LETTER REPORT REGARDING SOIL EXCAVATION PLAN FOR TANK SITE 365 NS
MAYPORT FL
12/11/2001
TETRA TECH NUS

Subject: Soil Excavation Plan
Tank Site 365
Naval Station Mayport
Mayport, Florida

RE: Draft Contamination Assessment Report Tank Site 365, Naval Station Mayport,
Mayport, FL

Figure 3

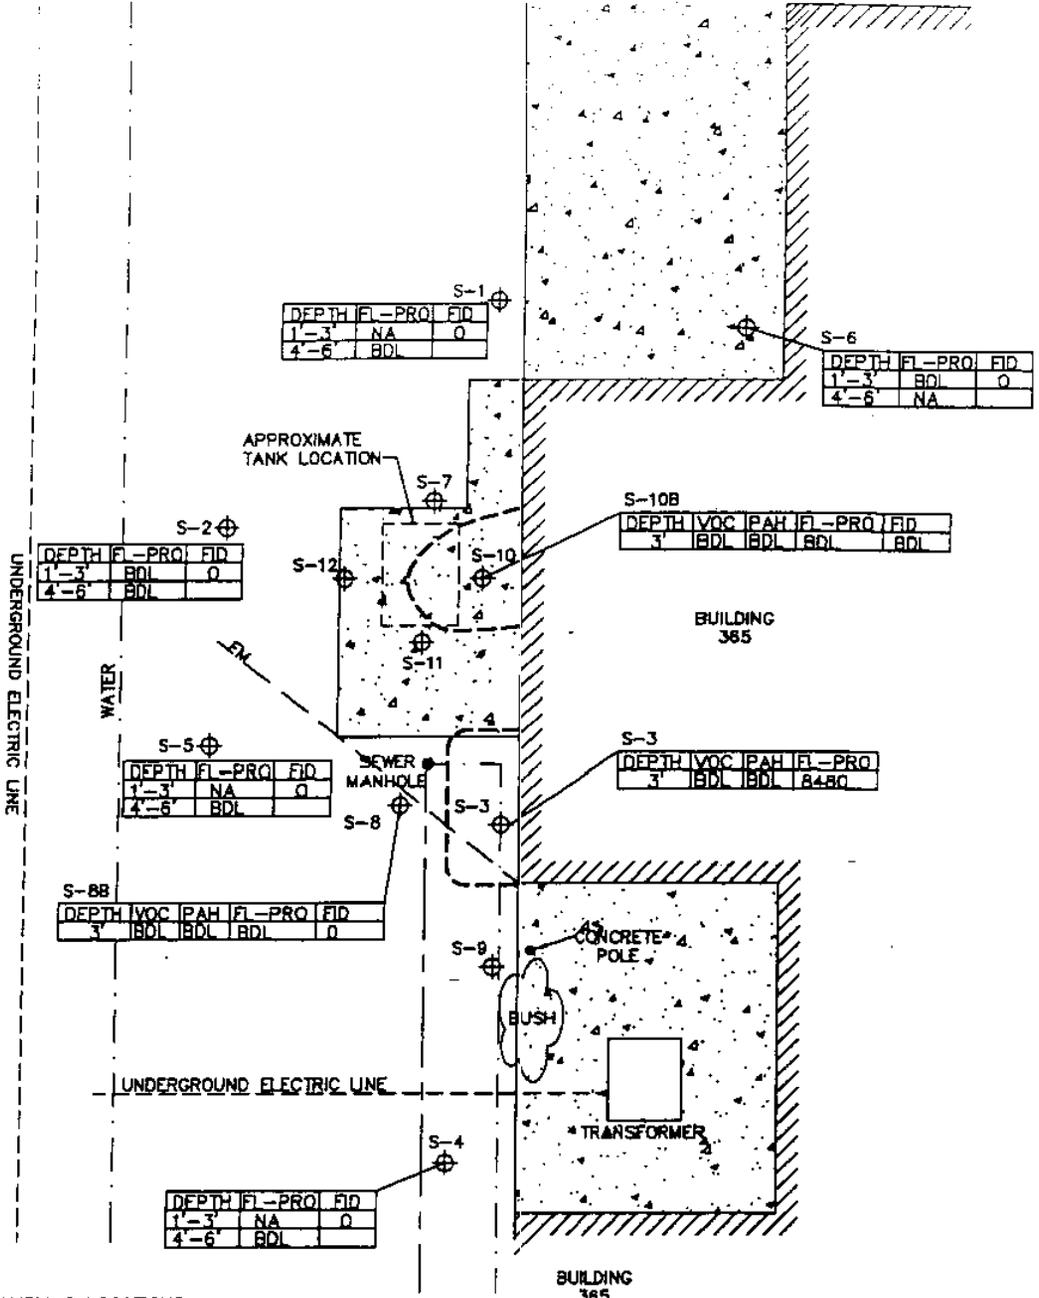
The excavation should center on boring S-3 shown in Figure 3 in Attachment A. The actual extent of the excavation will be defined in the field by the contractor via OVA soil screening and visual evidence of impact. It is anticipated that the excavation will extend to an approximate depth of 5 feet bls and should include impacted soils from the vadose zone. The lateral extent of the excavation is unknown, but may extend to the northwest approximately 5 feet, toward the original location of the UST and to the south approximately 5 feet. Due to the presence of utilities and the adjacent structure, hand digging methods may be necessary to complete the source removal.
